EPC STORMWATER REVIEW COMMENTS
IN ORANGE BOXES WITH BLACK TEXT

**FINAL DRAINAGE REPORT
FOR
LAZY Y AND ROCKING J SUBDIVISION**

PCD Filing No: PPR-2435 & SF-2428

DETENTION BASIN STAGE-STORAGE TABLE BUILDER

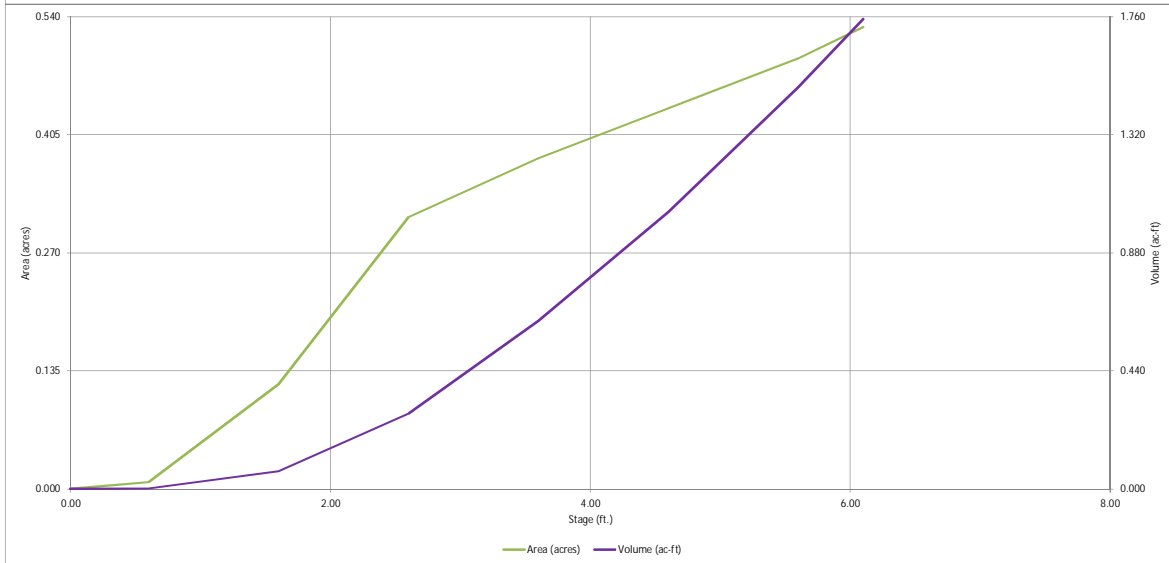
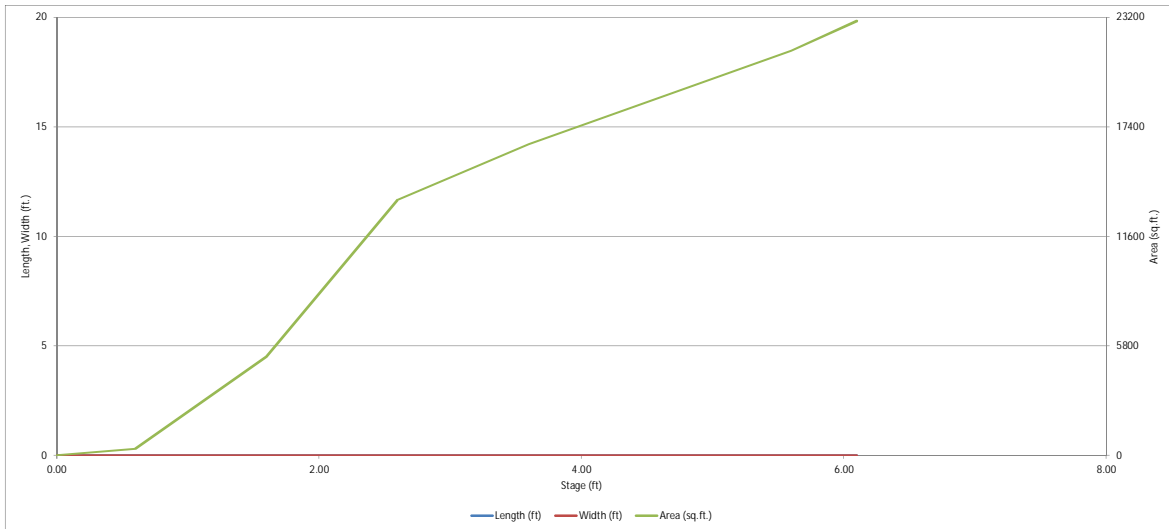
✓ = calcs match details in plans

✗ = calcs do not match details in plans

DETENTION BASIN STAGE-STORAGE TABLE BUILDER

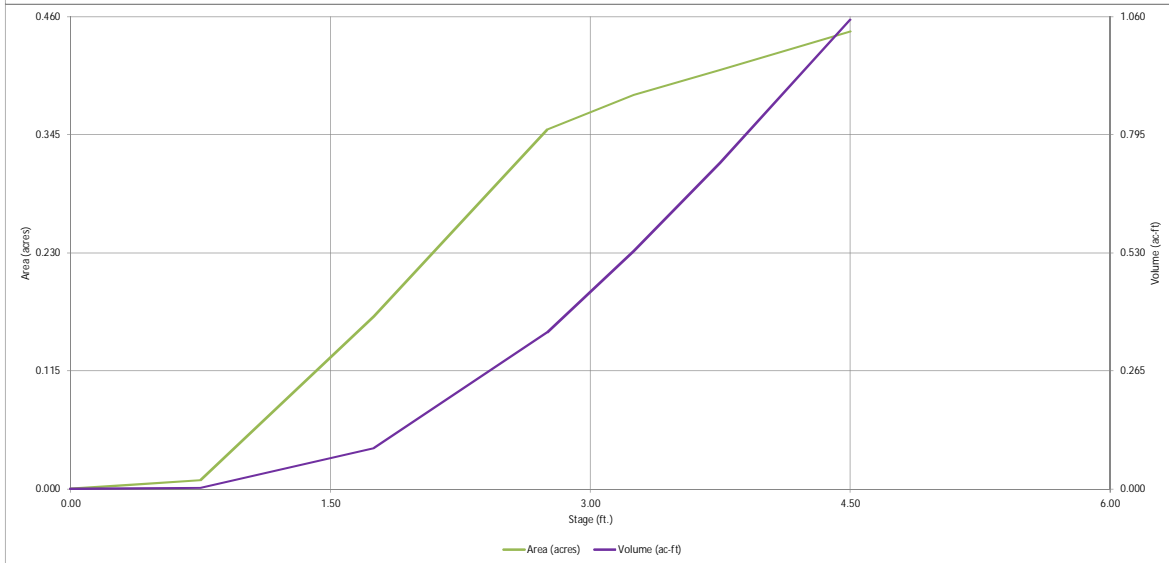
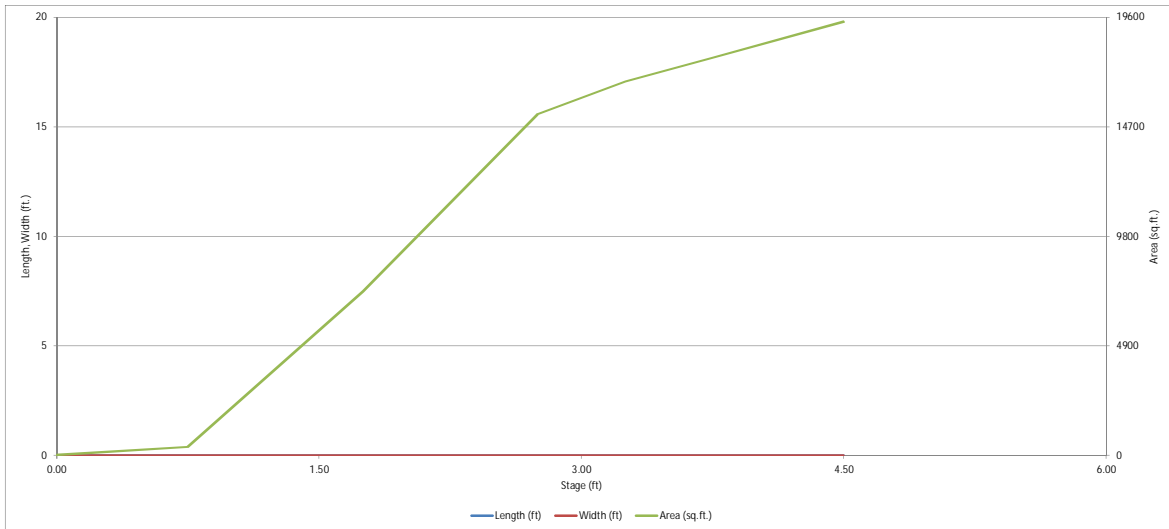
- ✓ = calcs match details in plans
- ✗ = calcs do not match details in plans
